Product Change Notification / MFOL-02RMEZ001

CCB 5351 Final Notice: Qualification of MMT as an additional assembly site for PAC1710-1-AIA-TR, PAC1720-1-AIA-TR, and PAC1921-1-AIA-TR catalog part numbers (CPN) available in 10L VDFN (3x3x0.9mm) package.

CCB 5351

Pre and Post Change Summary

LEADFRAME COMPARISON

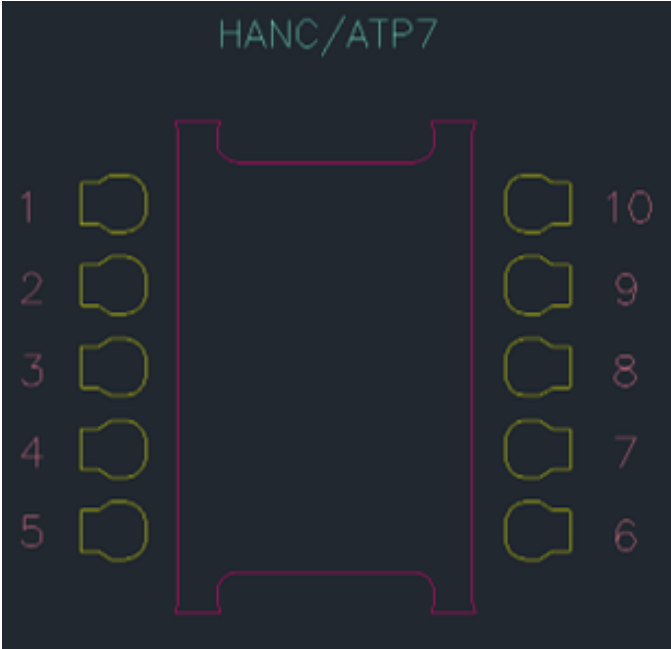
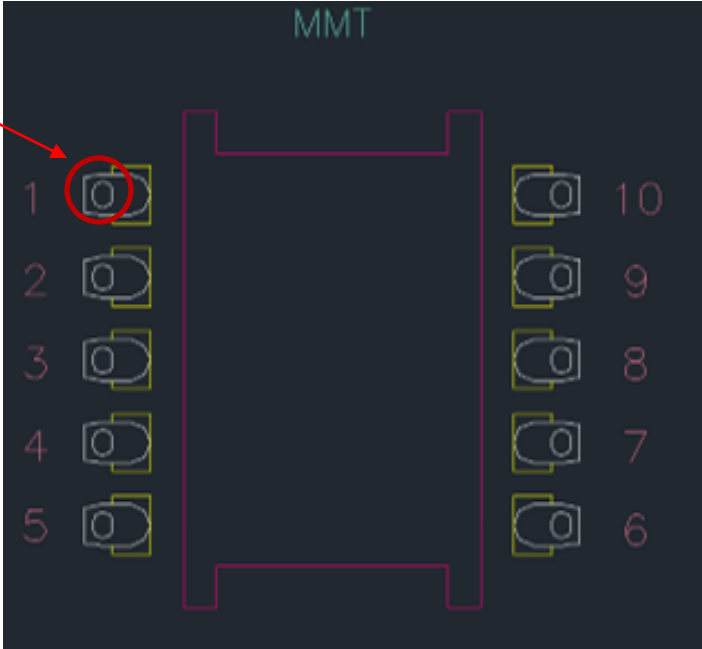
HANC / ATP7	MMT								
 <p>Diagram of HANC/ATP7 leadframe showing pins 1-10 and a central body.</p>	<p>Lead-lock</p>  <p>Diagram of MMT leadframe showing pins 1-10, a central body, and a lead-lock hole at pin 1.</p>								
<table><tr><td>Lead-lock</td><td>No</td></tr><tr><td>Lead frame Material</td><td>C194</td></tr></table>	Lead-lock	No	Lead frame Material	C194	<table><tr><td>Lead-lock</td><td>Yes</td></tr><tr><td>Lead frame Material</td><td>A194</td></tr></table>	Lead-lock	Yes	Lead frame Material	A194
Lead-lock	No								
Lead frame Material	C194								
Lead-lock	Yes								
Lead frame Material	A194

Note: Mold compound materials fills the leadlock hole, which provides improved protection against moisture penetration along the edge of the leads (pins) of the package.
